AMENDMENT TO FACILITY OPERATING LICENSE

SAFETY EVALUATION

BY THE OFFICE OF NUCLEAR REACTOR REGULATION
SUPPORTING AMENDMENT NO. 49 TO LICENSE NO. DPR-49

DUANE ARNOLD ENERGY CENTER

FIGURE 2: Analyzed Notch Configurations at Root of Safe End to Piping Weld (Weld #6)

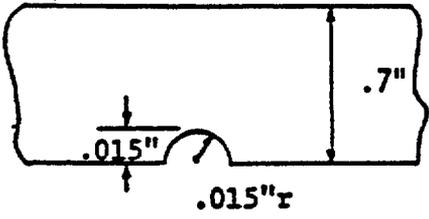
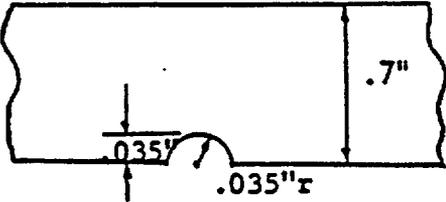
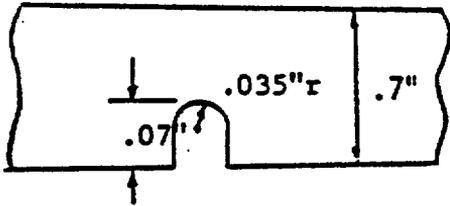
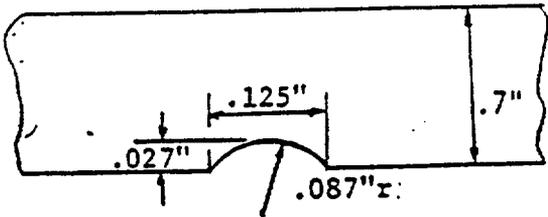
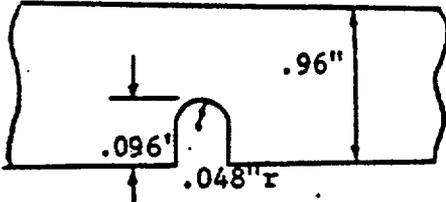
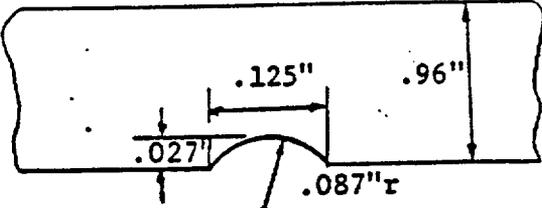
(see Figure 1) by assuming and analyzing six different notch configurations (see Figures 2 and 3). These notch configurations were chosen by the licensee to conservatively bound, relative to mechanical strength, the worst root conditions that could be inferred from the interpretation of the radiographic films. The worst-case condition enveloping all the stated variations is a sharp cup-shaped intrusion, with a depth of about 1/10 the wall thickness. This condition is designated as Case E* in the licensee's analyses. There are three possible adverse effects of this assumed worst-case root condition; adequate fatigue life, initiation of stress corrosion cracking, and initiation of brittle or unstable fracture without prior warning. These three possible effects are discussed below.

The licensee performed detailed stress analyses for weld locations 2 and 6 in accordance with the requirements of Section III of the ASME boiler and Pressure Vessel Code assuming the notch configurations shown in Figures 2 and 3. The results of the original stress analyses were modified to account for the reduced wall thickness at the assumed notches and to obtain primary stress intensities and primary plus secondary stress ranges. No credit was taken for any weld reinforcement at the outer weld surface. In addition, theoretical stress concentration factors were determined for Cases A through D and F for the calculation of the fatigue usage factors. For Case E, a fatigue strength reduction factor of 4.0 was used which is the highest value required by the ASME Boiler and Pressure Vessel Code for a partial penetration weld.

The analysis of weld numbers 2 and 6 for each of the assumed notch configurations, considering the reduced wall thickness and the fatigue reduction factors, show that the calculated stresses and fatigue usage factors are within the limits prescribed by Section III of the ASME Boiler and Pressure Vessel Code.

The staff has evaluated the fatigue analysis and agrees with the licensee's evaluation.
